Recall Bulletin

Transport Canada Recall Number: 04-331

National Traffic and Motor Vehicle Safety Number (NHTSA): 04V-447

SAFETY DEFECT - Locking Pin Upgrade to Battery Tray

Figure 1-1 Quick Release Pin Hole

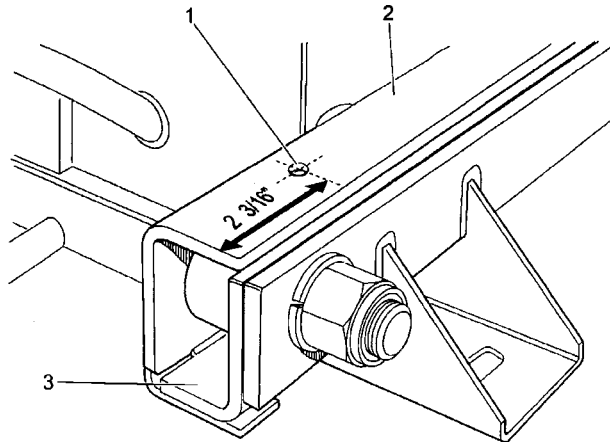
Orion Bus Industries Inc. has decided that a defect, which relates to motor vehicle safety act, exists in some of its transit buses. The battery tray could possibly slide out, while the vehicle is in motion, resulting in a potential vehicle collision.

1. Using a square key lock, open the battery compartment door, located on the rear curbside of the vehicle.
2. Move the isolator switch to the OFF position.
3. Drill 2 3/16" from the center edge of the battery tray arm (2), a 3/8" hole (1). Refer to **Figure 1-1**.

Ensure that the hole completely goes through the bottom plate (3). Refer to Figure 1-1.

We have determined that Orion Locking Pin Upgrade to Battery Tray Recall (Transport Canada Recall Number: 04-331 or National Traffic and Motor Vehicle Safety (NHTSA) Number: 04V-447) has an incorrect dimension. The correct dimension for drilling the locating hole is 2.19 in. from the end.

Figure 1-2 Installing the Quick Release Pin Assembly

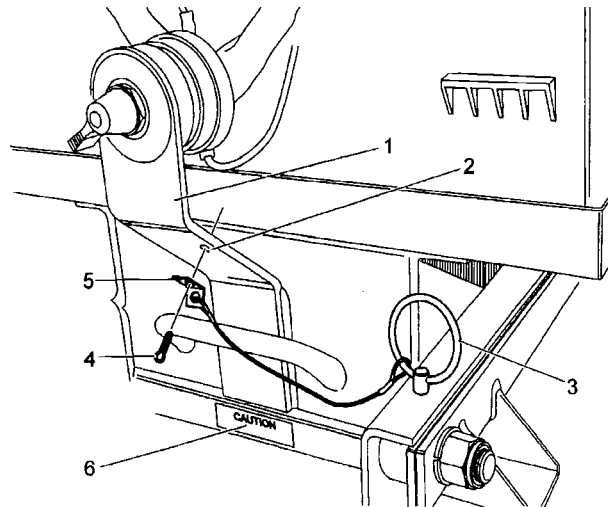
4. Drill a 13/64" hole (2) on the right side of the lower half of the isolator switch bracket (1). Refer to **Figure 1-2**.
 5. Work the quick release pin (3) through the 3/8" hole on the battery tray arm. Refer to **Figure 1-2**.

6. Place the quick release pin tab (5), over the 13/64" hole (2) and secure with a cotter pin (4). Refer to **Figure 1-2**.
